Eastowne SUP
Medical Office Building
Town Council Presentation

Town Council Concerns and Responses Executive Summary

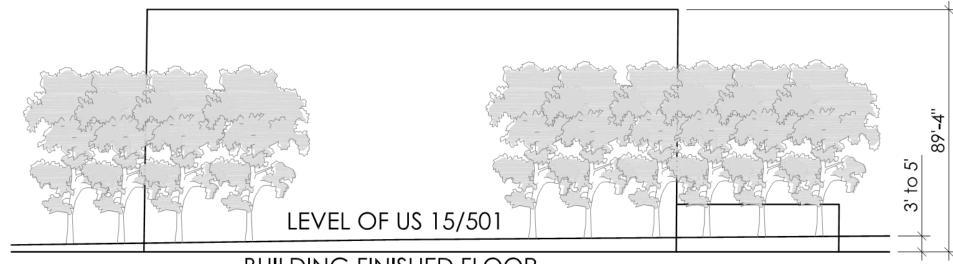
2. It appears that the building will be 105 feet high, equivalent, perhaps, to a nine-story building. This building is too tall for the area and becomes the precedent for all future buildings in the area.

Applicant Response: The proposed building is 6 stories (14' 0" typ x 6 + parapet) or 89'-4" with a ceiling height of 9 feet which provides additional clearance for specialty HVAC. Reducing floor to floor heights will lower the building height to under 90', which is modified from 95'. See following elevation and floor to floor section illustrating use of heights specified.

2. Section Elevation: The following diagram shows the overall height of the building from finished floor elevation to its highest point as well as the varying building height relative to 15-501. Please note that 15-501 is above the finished elevation of the building.

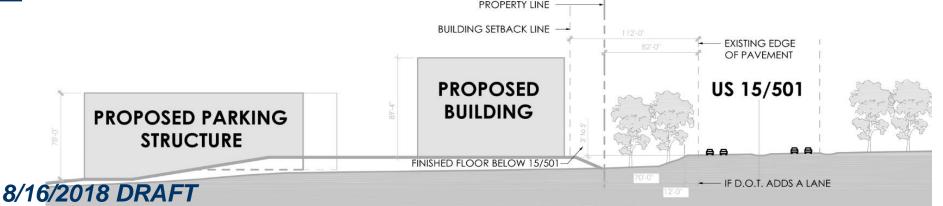
3. This sets the tone for the whole 15-501 corridor. Will there be requests for even higher buildings in this section of town? With Gateway & SECU Developments, the feel of coming into such tall buildings at this main entrance to Chapel Hill is important. / Being so large so close to the road, makes the building feel even bigger. Our interest is urban design but not at the expense of feeling like a canyon down 15-501

Applicant Response: Building is set back from 15-501 a distance of 112'. We are proposing to preserve a considerable amount of the buffer vegetation and even with future road widening along 15-501, there will still be 100' of separation. The required on-site 30' buffer is being maintained. Also, please note that the building height is less than the set back from the edge of payment.

This creates a commonly accepted 1 to 1 ratio.

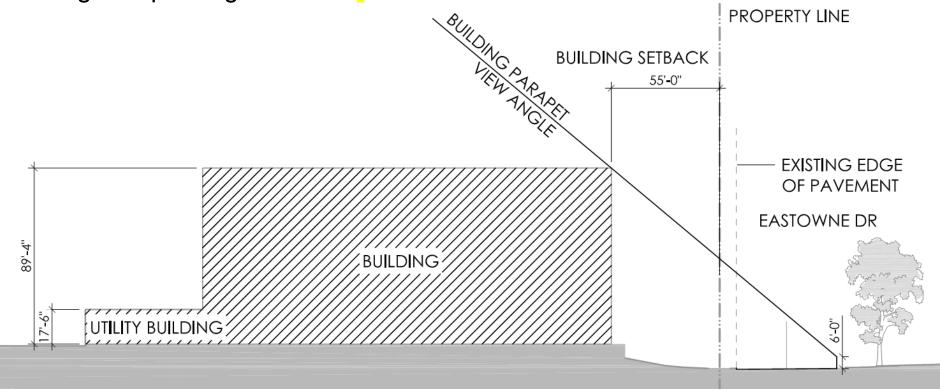
3. cont'd.

Applicant Response: Building is set back from Eastowne by 55' and parking deck by 52'. Below is a site section showing position of Eastowne relative to building and parking structure.

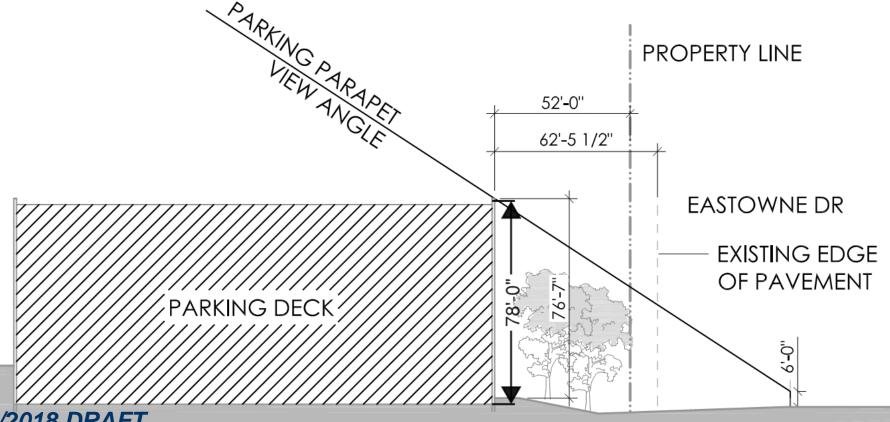
3. cont'd.

Applicant Response: Building is set back from Eastowne Drive by 55' and the Parking Deck is set back by 52'. Below is a site section showing position of Eastowne Drive relative to building and parking structure.

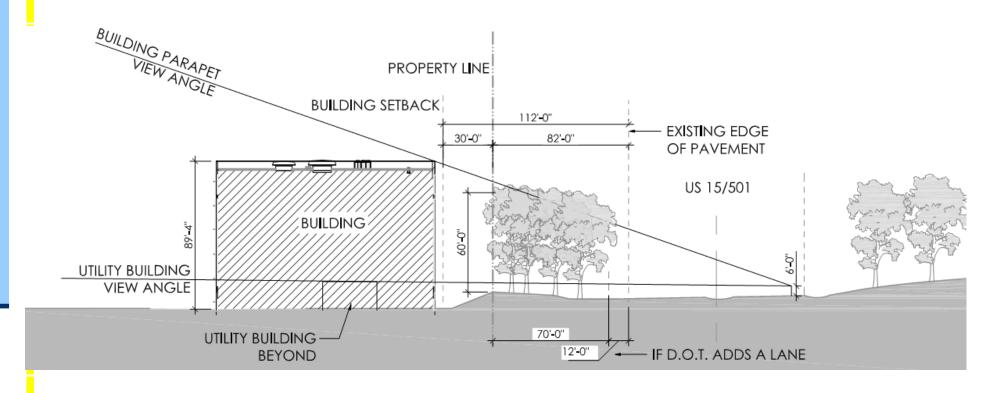
4. Is a basement level a strategy to reduce overall height?

Applicant Response: A basement is not practical for this project due to costs of rock excavation and foundation walls, an increase of required rock blasting, and access to daylight for patients.

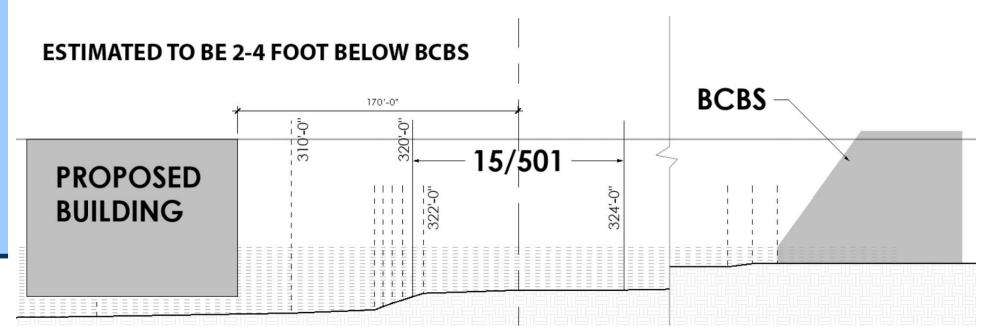
5. Where is the best place for the mechanicals of the building?

Applicant Response: There are small fans and mechanical equipment located on the roof within the 90' limit on height. Air cooled chillers are located and screened behind the small, single story utility building which is located approximately 10' below 15-501 elevations and any exterior mechanical units will also be shielded from view by an evergreen landscape. See following line of sight drawing for further clarification.

5. Illustrations:

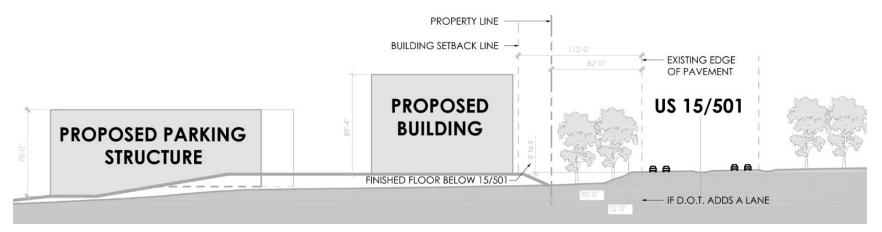
7. How tall will the building be from each corner to the ground?

Applicant Response: The topography around the building varies; therefore, we have shown multiple heights along 15-501 to try and clarify building height at FFE versus the topography created in the grading plans. Please see exhibit on the following slide.

Eastowne Road

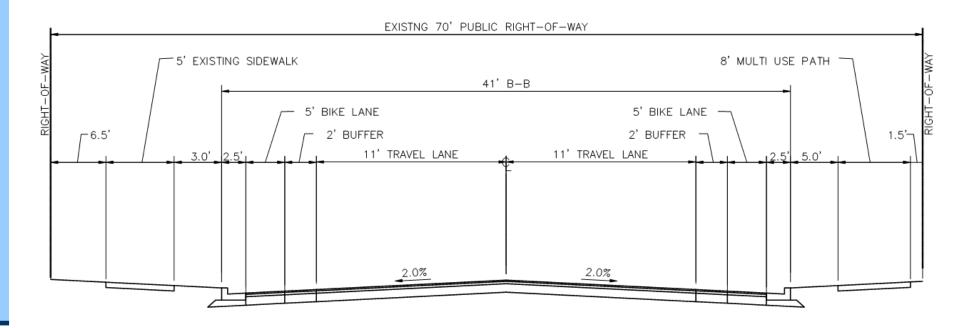
12. Need to make sure there is space left along Eastowne Road in case it has to be widened at some point in the future – turn lane width or additional lanes. Building placement should not preclude this –

Applicant Response: We will defer to Staff's response and are supportive of their recommendation.

Staff Response: Town staff identified a possible cross section based on the draft Town Design Manual. The cross-section would have two 11' travel lanes; one 10' turn lane at intersections; two 5' bike lanes with buffer; planting strip; and sidewalks. The placement of the building and the parking deck would be located outside of these right-of-way requirements. Please see following drawing for clarity.

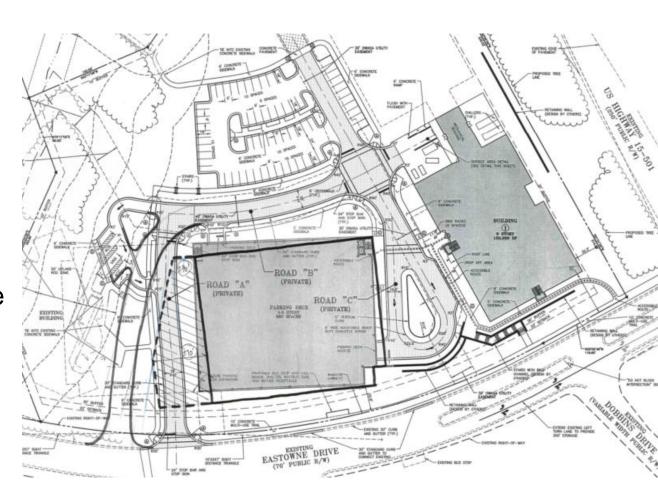
13. Consider traffic circle in front of parking deck – there is already a great number of cars coming down Eastowne Rd from other medical & apartment complex such that making a left turn out of the parking deck onto Eastowne Rd is complicated – maybe not for first building but for full build out – at least plan for this to help with traffic flow. Adding this number of cars into one entrance is huge for this section of road – traffic circle or something to keep movement and prevent stacking in either direction

13. Cont'd.

Applicant Response: We considered a traffic circle at this location and determined it created several impacts to the project and adjacent landowners, including the loss of full access movement for Pinegate Apartments, and impact on existing environmental features. A traffic circle may be viable with the future Pinegate redevelopment but should be evaluated with overall Master Plan.

Staff Response: We believe placement of a traffic circle at the parking deck entrance may cause conflict with the Pinegate Apartments driveway. It is recommended as part of the Master Plan traffic impact scope of work that a traffic circle be considered at the intersection of Eastowne Drive and Old Sterling Drive.

Greenway/Bike Path

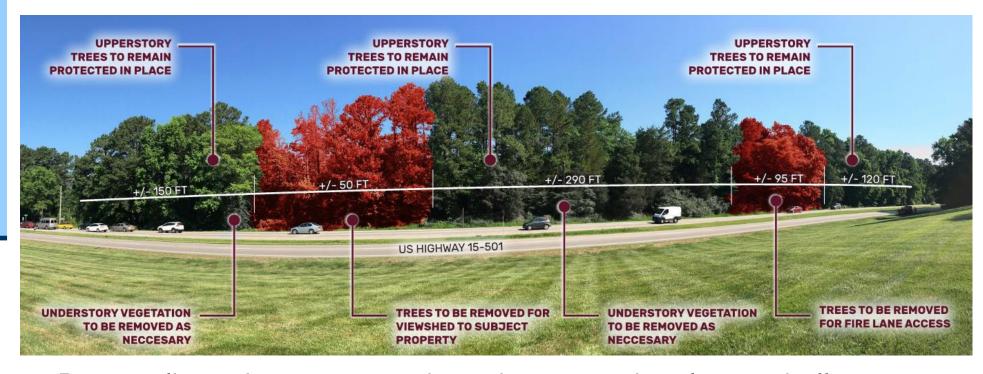
15. Cont'd.

Applicant Response: We have removed the greenway trail along 15-501 and are open to having a pedestrian connection go thru this site and connect to future greenway as part of the masterplan.

Staff Response: The developer is considering connection of multi-use paths through the entire Eastowne property. A stipulation has been included in Revised Resolution A. Bicycle and pedestrian facilities are recommended along Eastowne Drive providing connections to Old Sterling Drive and Dobbins Drive.

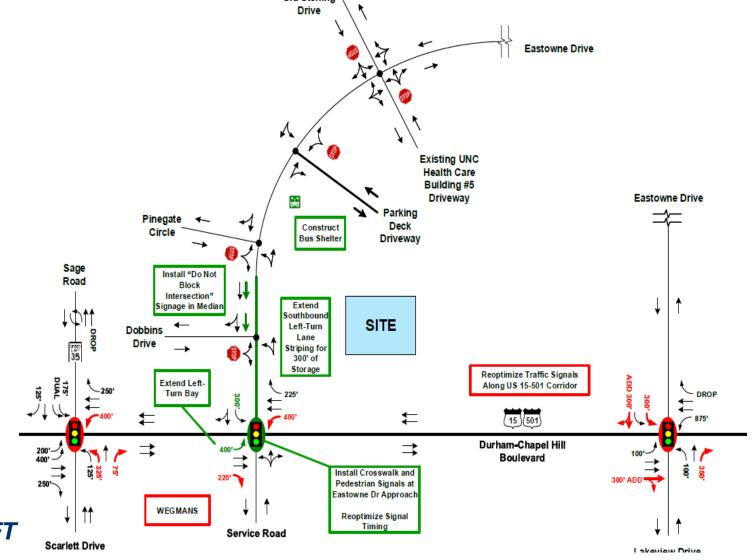
20. What specific improvements are required?

Staff Response: Improvements required are shown below:

- Extend northbound left-turn lane on 15-501 to 400' for added vehicle queuing;
- Extend Eastowne Drive left-turn lane onto 15-501 to 300' for added vehicle queuing;
- Install crosswalk and pedestrian signals at Eastowne Drive for improved passage across 15-501 and a connection to the future Wegmans;
- Construct a new bus shelter along Eastowne Drive adjacent to proposed development;
- Install "Do Not Block Intersection" signage in median along Eastowne Drive.

The following improvements are required prior to issuance of a Certificate of Occupancy, if not installed by the future Wegmans:

- Reoptimization of traffic signal timing on US 15-501;
- Add a second 300' left lane from Eastowne Drive to US 15-501.

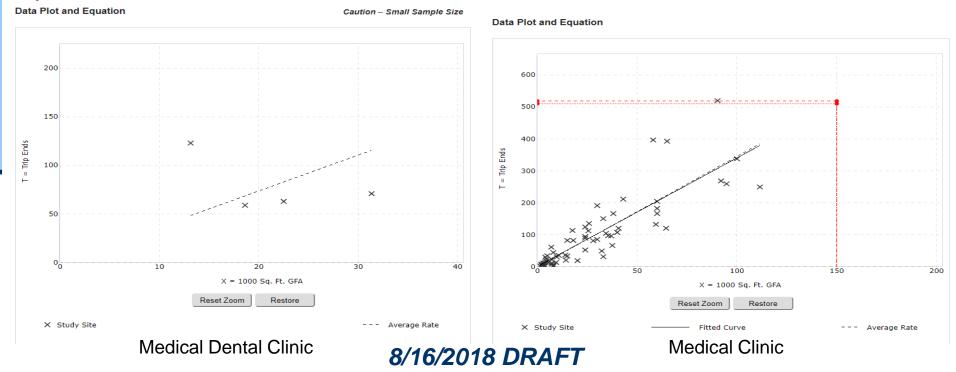
25. How did the consultant incorporate the ITE Manual when making trip generation calculations for the Eastowne project?

Staff Response: The consultant reviewed the available ITE Manual data on land uses related to the proposed UNC Health Care facility (720 – Medical-Dental Office Building, 630 - Medical Clinic), as well as the existing facilities. There are two trip generation options for these land uses – number of employees and square footage. Based on the ITE Manual data available and compared to the applicant-supplied information, the consultant determined that the number of employees was the most appropriate variable to use.

A second consideration is the particular land use type (or "code") from the manual that best approximates the land use in the proposed project. In this case, the consultant averaged the trip generation results of the two land use codes listed above to best approximate the land use in the Eastowne project. For the existing site, the Applicant shared that the existing facilities function as general office buildings (not clinics), so the ITE Manual code for General Office Buildings (710) was utilized to estimate existing trip generation of the fully utilized existing facilities.
